SITING AND GRADING PLAN

BLOCK 55 TEMPEL STREET Royal Pine Homes / Centerfield Properties Inc - 216102 "OAKRIDGE MEADOWS", RICHMOND HILL, ON

BLOCK 55

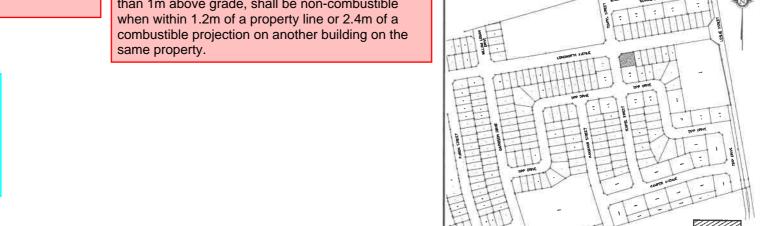
No unprotected openings permitted within 1.2 meters of the lot line as per article 9.10.14 of the Ontario Building Code.

As per OBC 2012, Div.B, 9.10.14.5(5), projections such as balconies, eaves, stairs, etc., that are more than 1m above grade, shall be non-combustible when within 1.2m of a property line or 2.4m of a combustible projection on another building on the same property.
